April 29, 1994
LD-94-032

Docket No. 52-002

Subject: Response to Comments on Design Certification Material

CE 80 + ITAAC Independent Review Comments

FIGURE 2.7.21-1
CONTAINMENT PURGE VENTILATION SYSTEM (LOW PURGE)

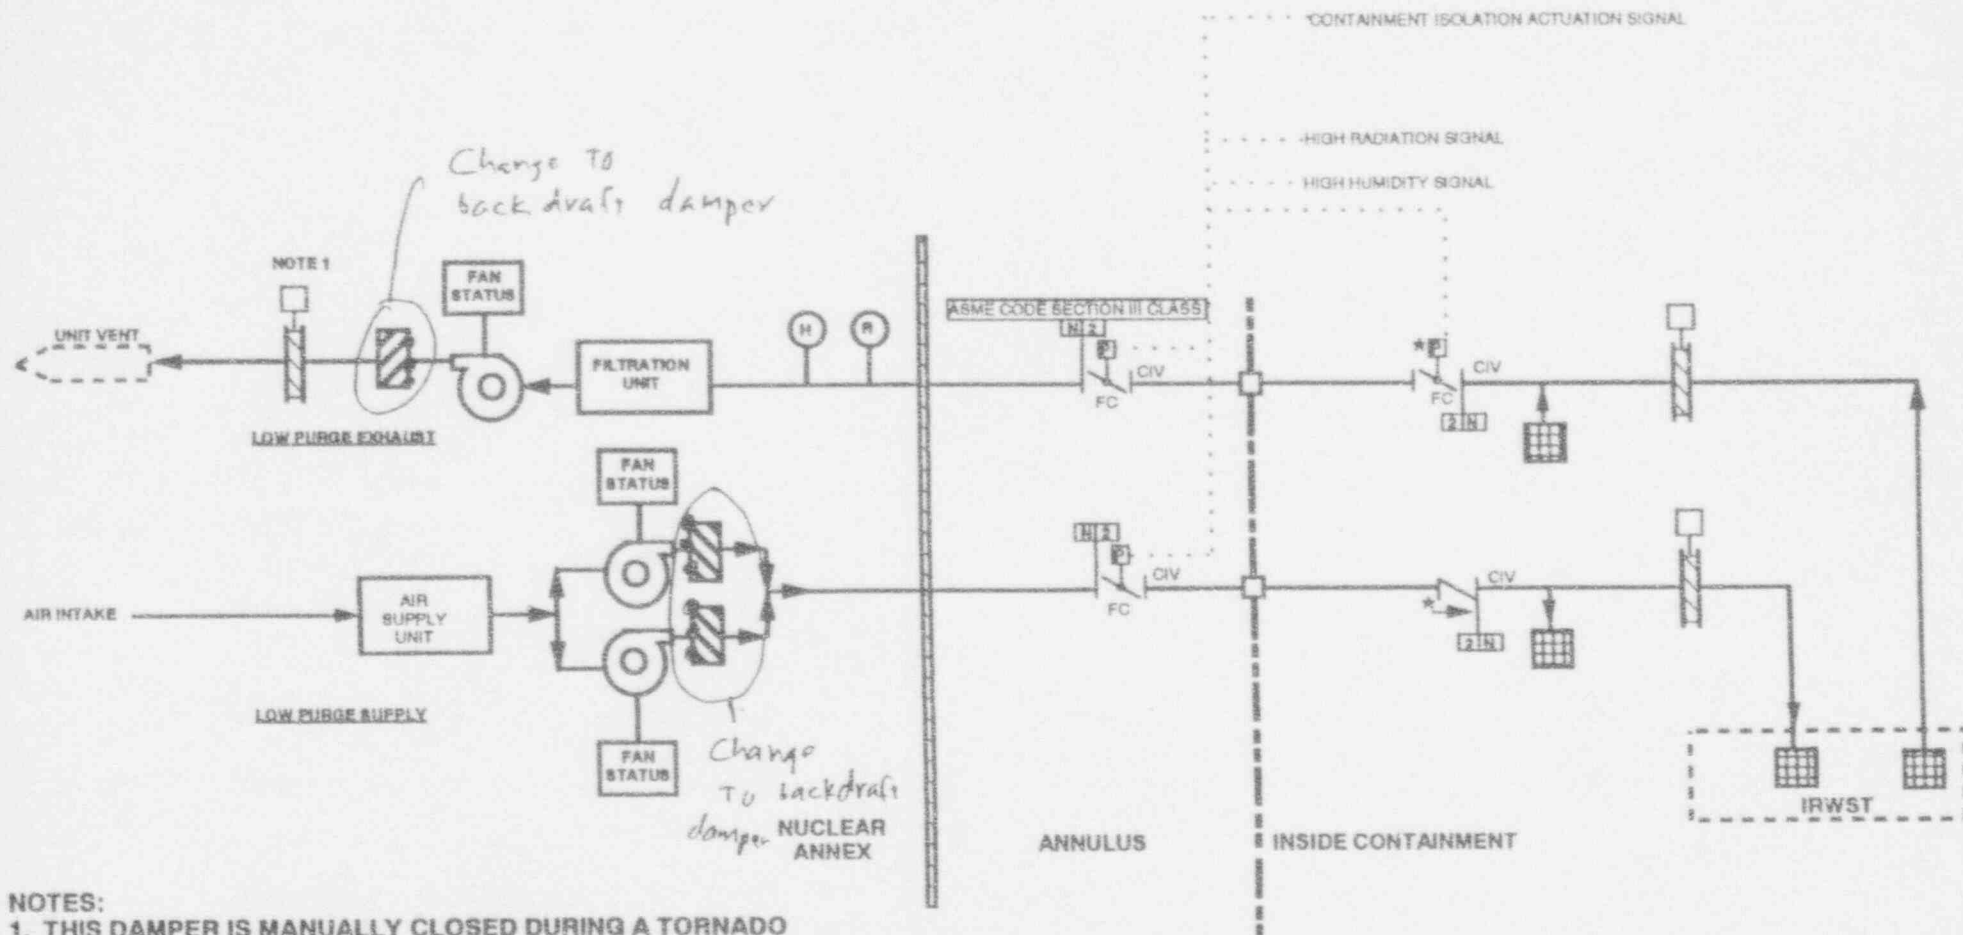
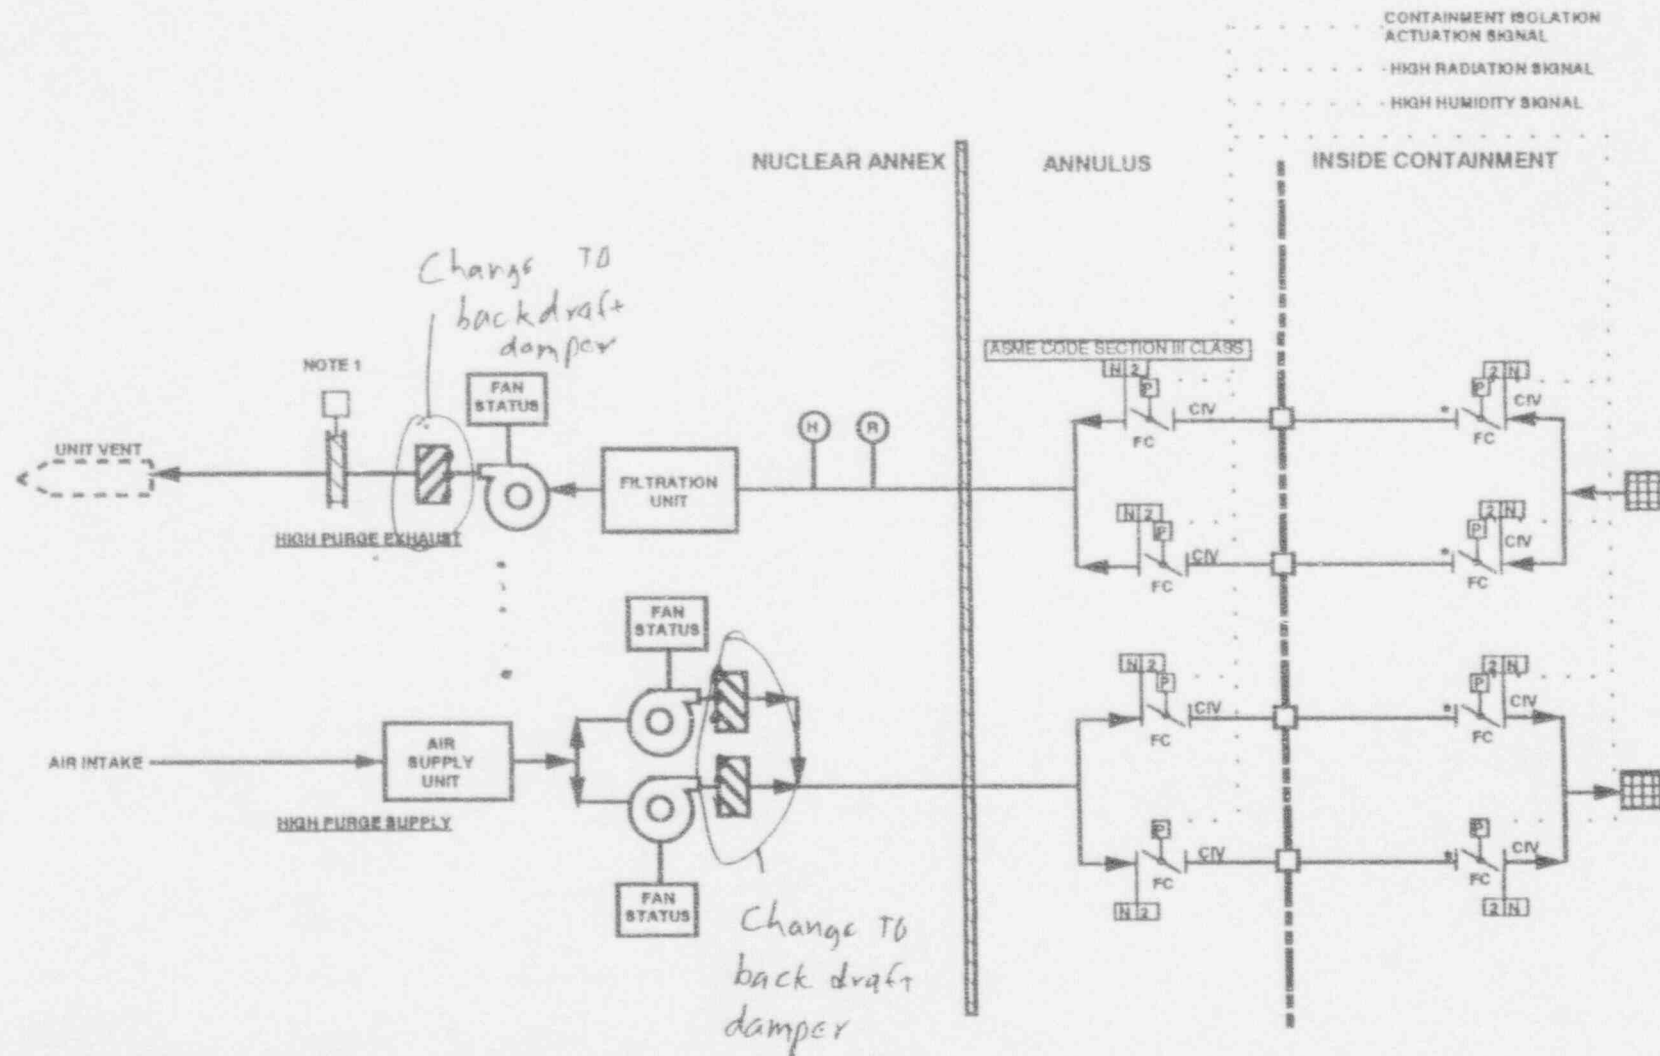
No.	Comments	Cat.	Resolution
1	Figure 2.7.21-1 and -2 should have back draft dampers on the discharge side of fans. CESSAR Figure 9.4.6.		Agree. See markup of ITAAC Figures 2.7.21-1 and 2.

FIGURE 2.7.22-1
CONTAINMENT COOLING AND VENTILATION SYSTEM

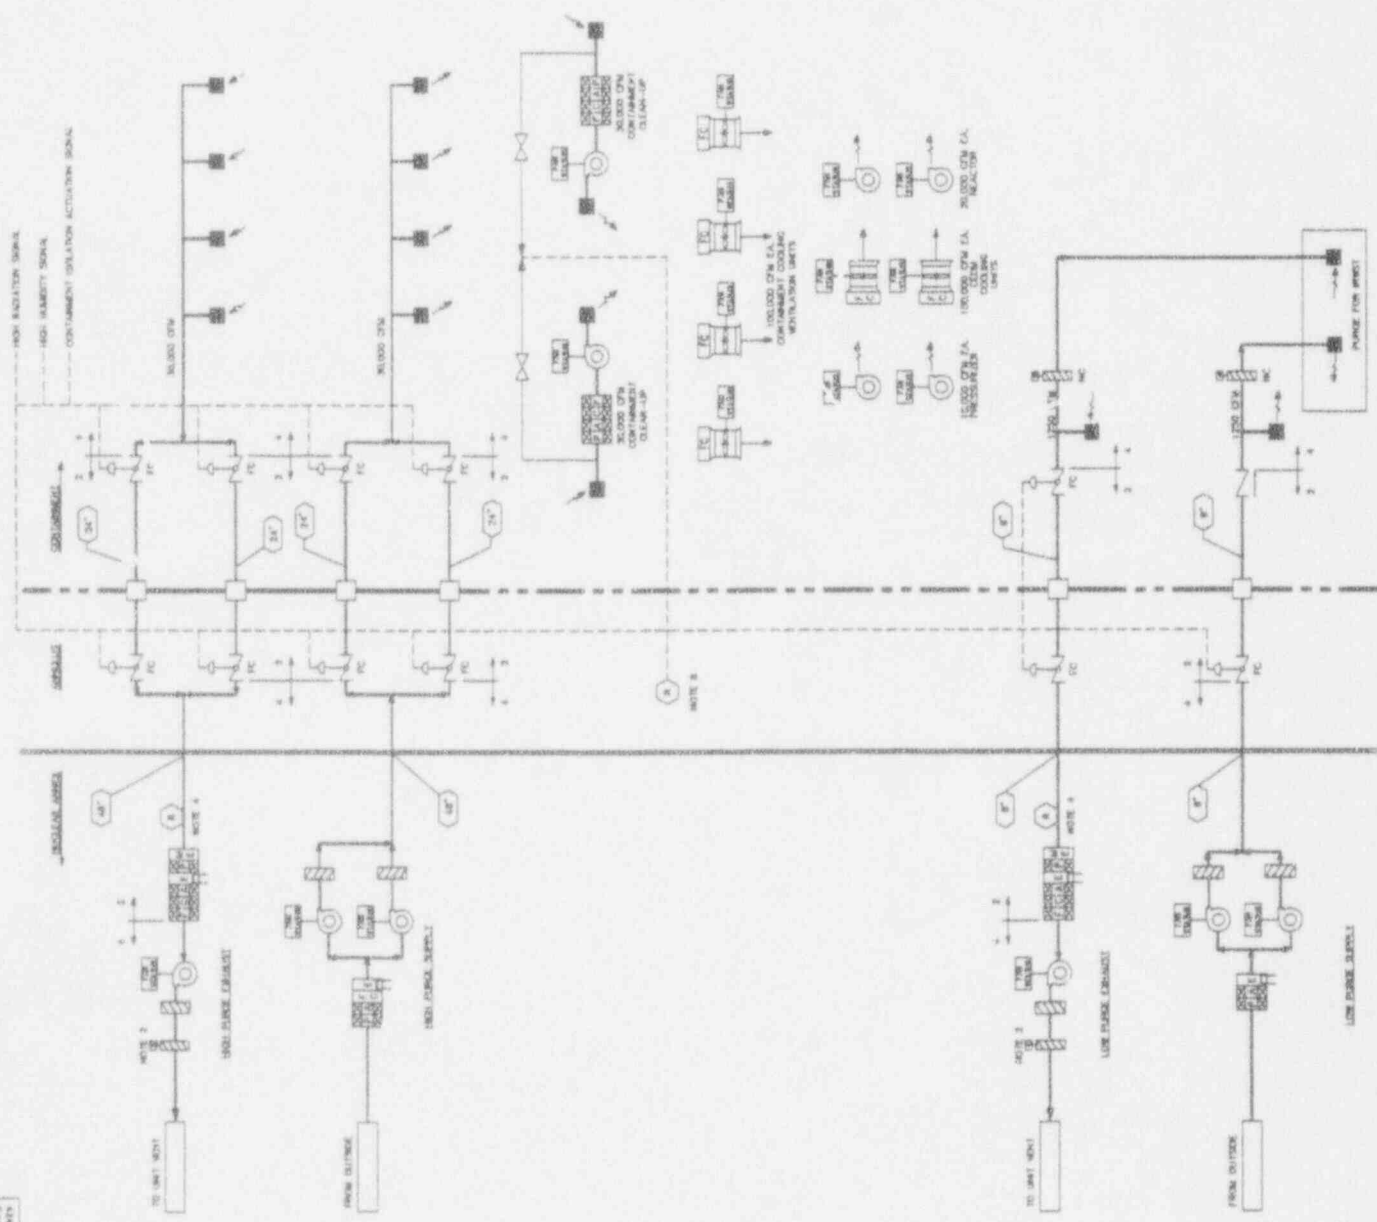
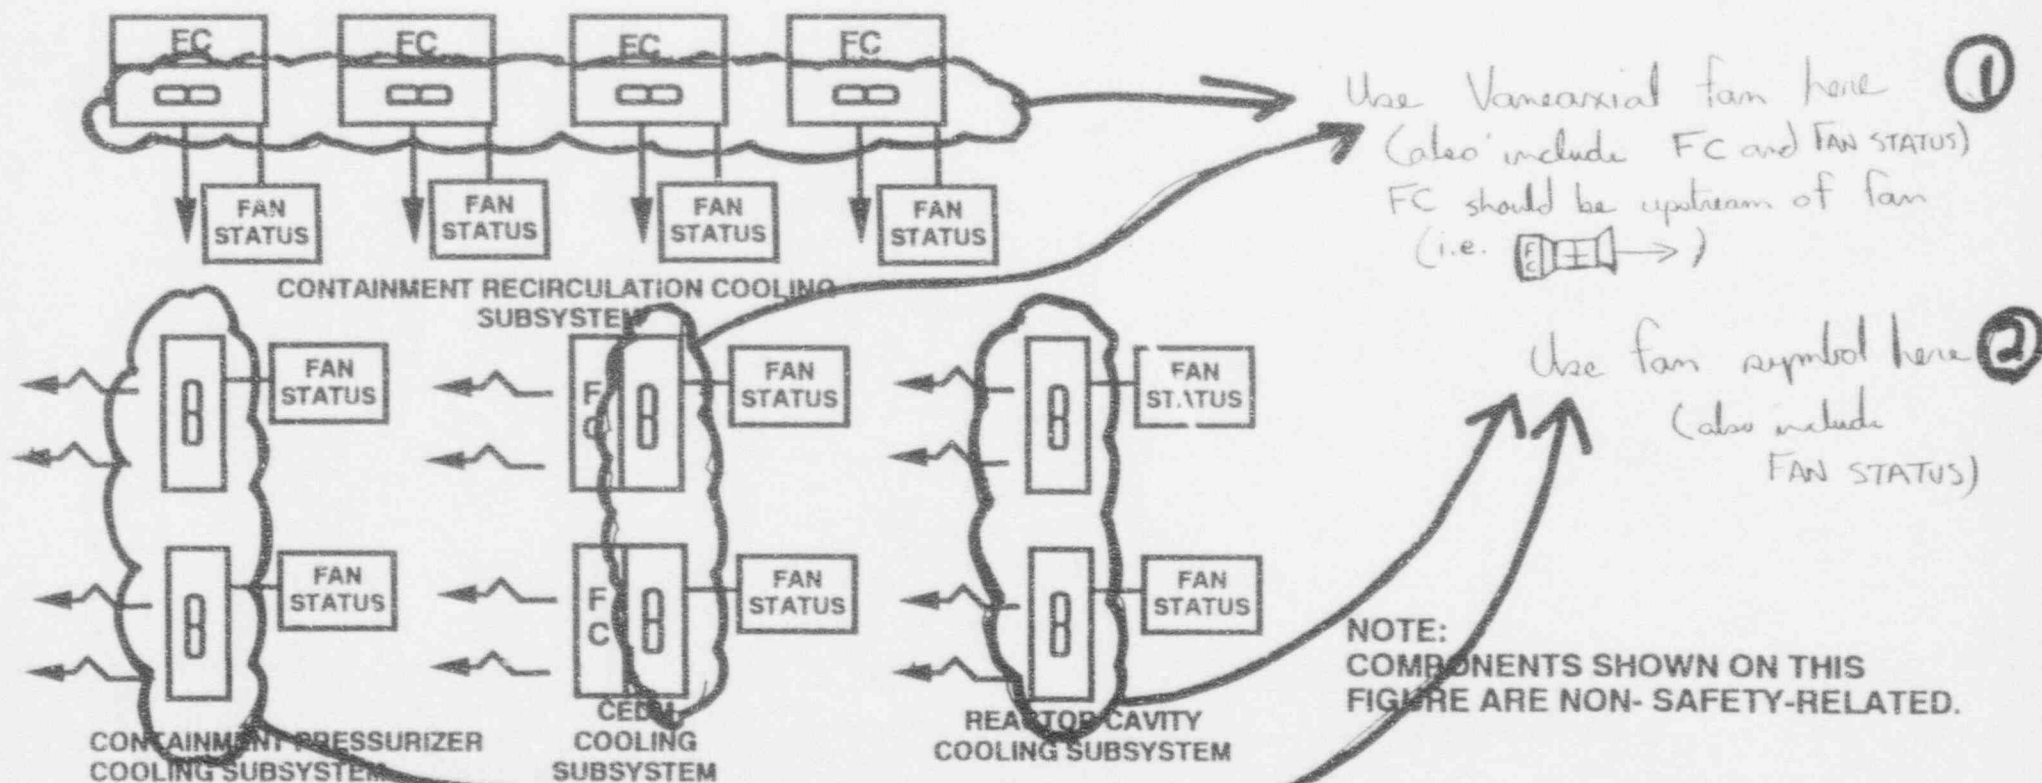
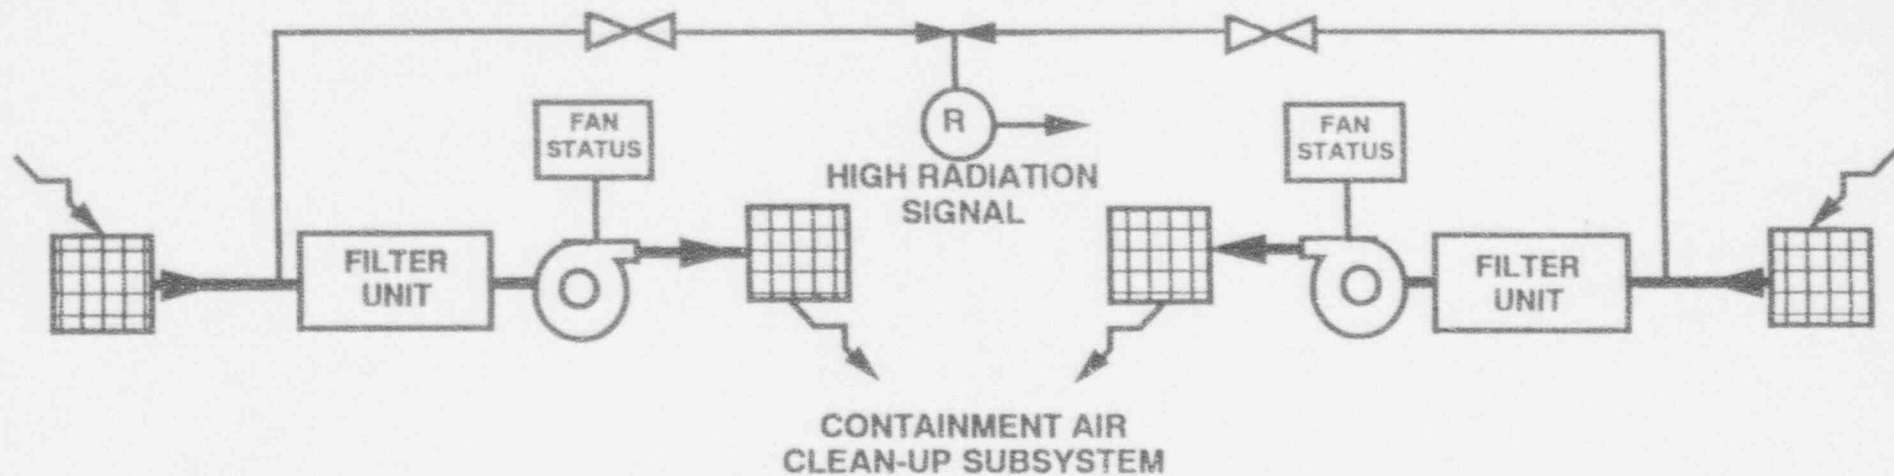
No.	Comments	Cat.	Resolution
1	Figure 2.7.22-1 does not use the standard fan symbol.		Agree. The Containment Recirculation Cooling Fans and CEDM Fans will be revised to the axial vane symbol and the Containment Pressurizer Fans and Reactor Cavity Fans will be revised to the standard fan symbol. See revision to Containment Cooling and Ventilation System Air Flow Diagram and markup of ITAAC Figure 2.7.22-1.

FIGURE 2.8.2-1
MAIN STEAM SUPPLY SYSTEM
(ARRANGEMENT SHOWN FOR ONE STEAM GENERATOR)

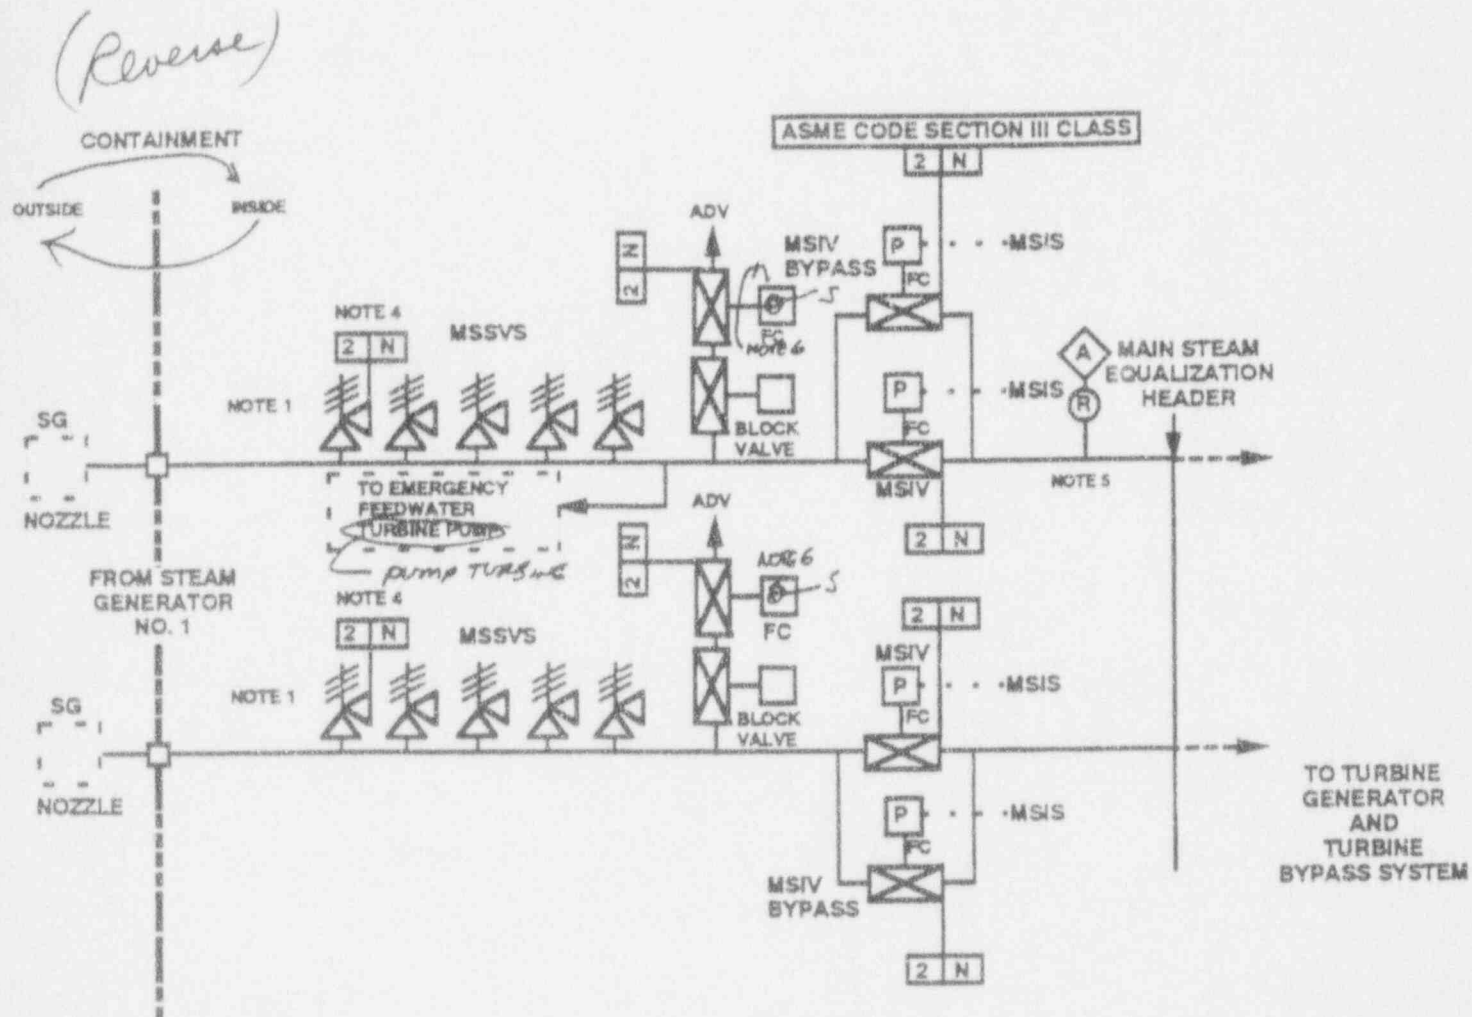
No.	Comments	Cat.	Resolution
1	See attached figure markup.	1	Agree. Will clarify the ADV operators. See markups.
